SUBJECT: COOPER NUCLEAR STATION - AMENDMENT NO. 125 TO FACILITY  
OPERATING LICENSE NO. DPR-46 (TAC NO. 68647)

Amendment No. 125  
License No. DPR-46

SAFETY EVALUATION BY THE OFFICE OF NUCLEAR REACTOR REGULATION  
RELATED TO AMENDMENT NO. 125 TO FACILITY OPERATING LICENSE NO. DPR-46

MSIV PNEUMATIC CONTROL UNIT

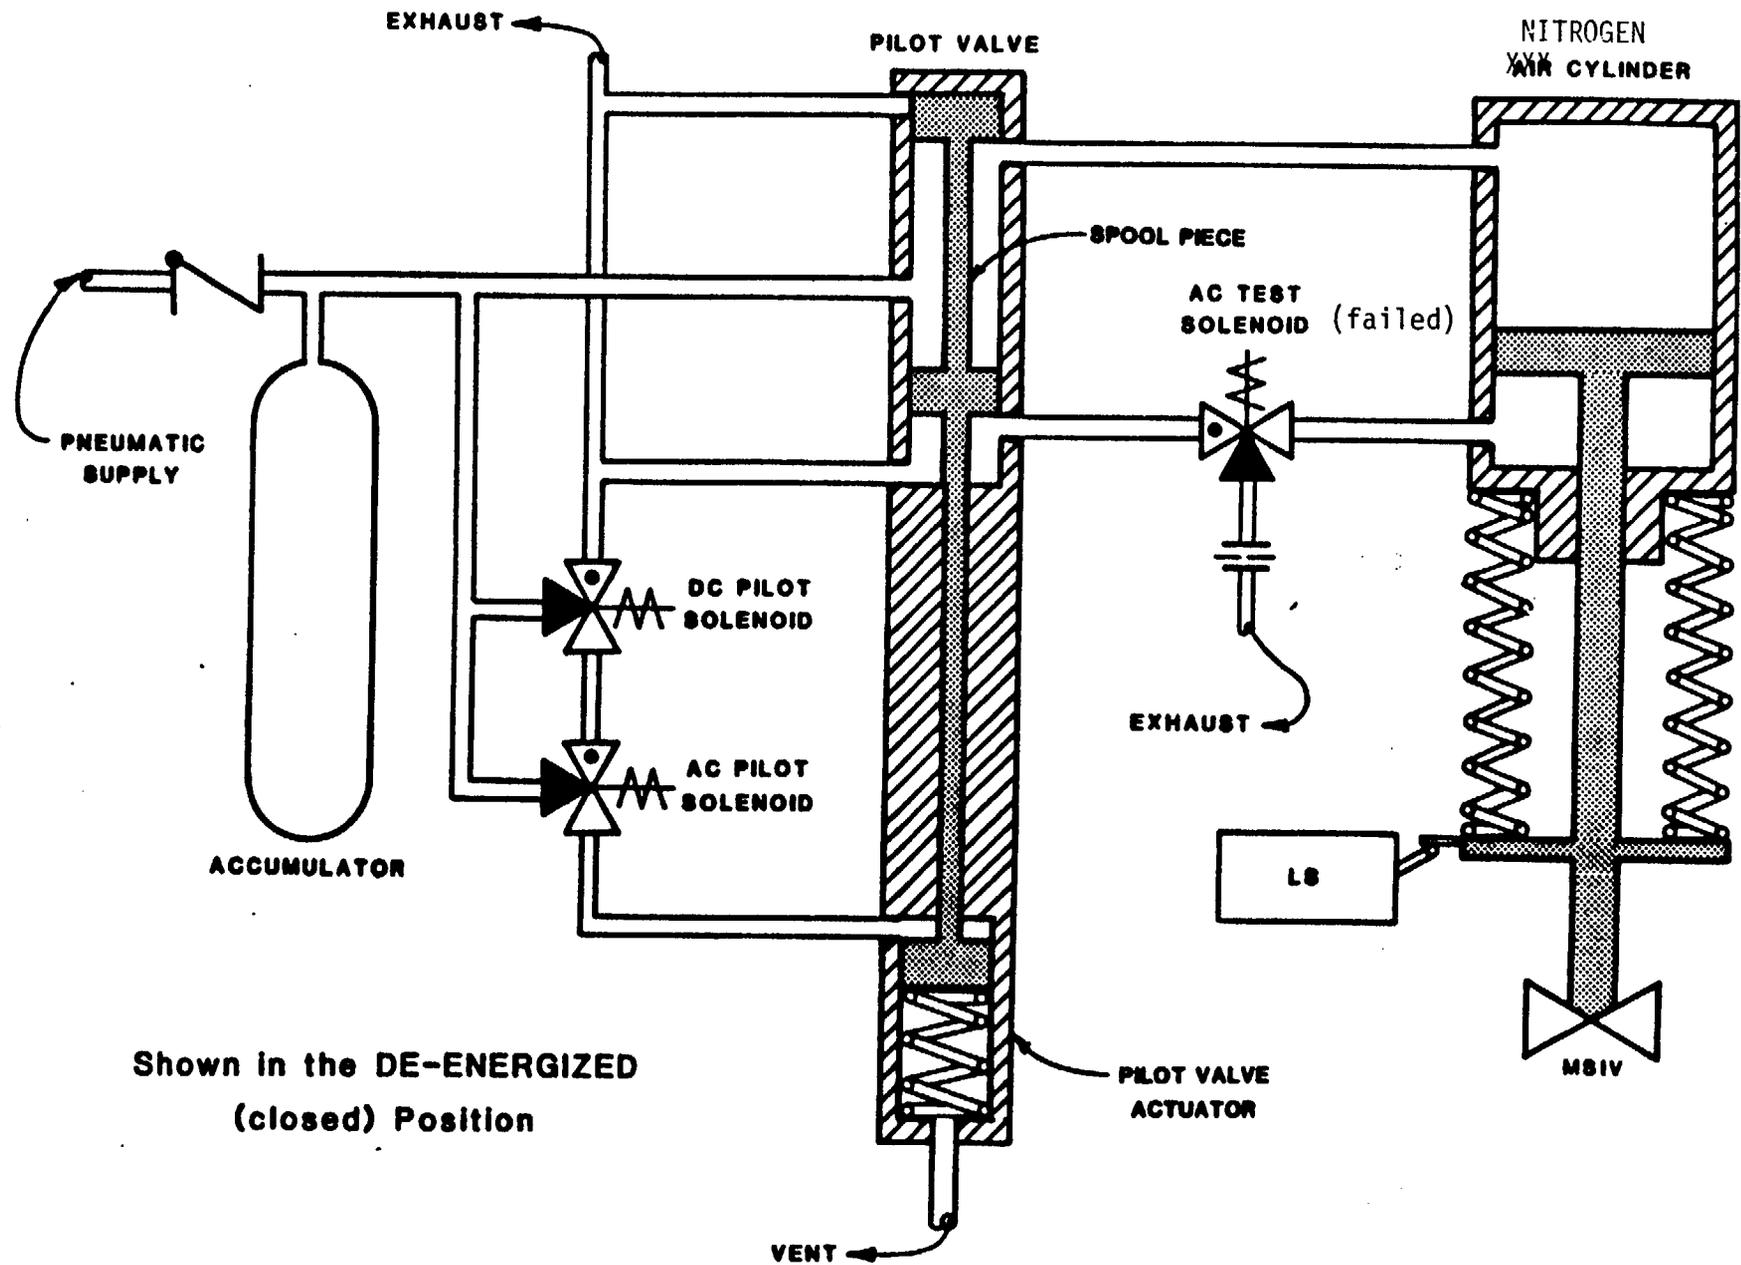
Cooper Nuclear Station (CNS) Technical Specification 4.7.D.1.c requires that each MSIV be partially stroked closed and reopened at least once per week during power operation. The licensee recently attempted to conduct this surveillance and was not able to complete the test on one of the inside-containment MSIVs. The inability to complete the test was attributed a failure of the solenoid-operated test valve which bleeds nitrogen from the MSIV power cylinder through a restricting orifice (see enclosed Figure). The test valve is installed solely for the purpose of enabling the MSIV to be slowly, partially-stroked open for the weekly surveillance. The test solenoid valve is normally closed and is not required to actuate in order for the associated MSIV to perform its required safety function which is to close within 3-5 seconds upon a Group I isolation signal.

Upon identifying that the MSIV could not be partially-stroked, the licensee performed the full stroke/rapid closure test required quarterly by Technical Specification 4.7.D.1.b.(2). The full-stroke test requires that reactor power be reduced. Because the test solenoid valve is inaccessible for repair during power operation, the licensee is continuing to perform the full stroke test on a weekly basis pending the relief of this amendment. The staff acknowledges that the failure to satisfactorily complete the partial-stroke test is not indicative of MSIV inoperability if the full-stroke test can be successfully accomplished.

Since the proposed technical specification is consistent with existing testing requirements as reflected in the ASME Code Section XI, the licensee's proposed amendment deleting the weekly MSIV partial-stroke test is acceptable.
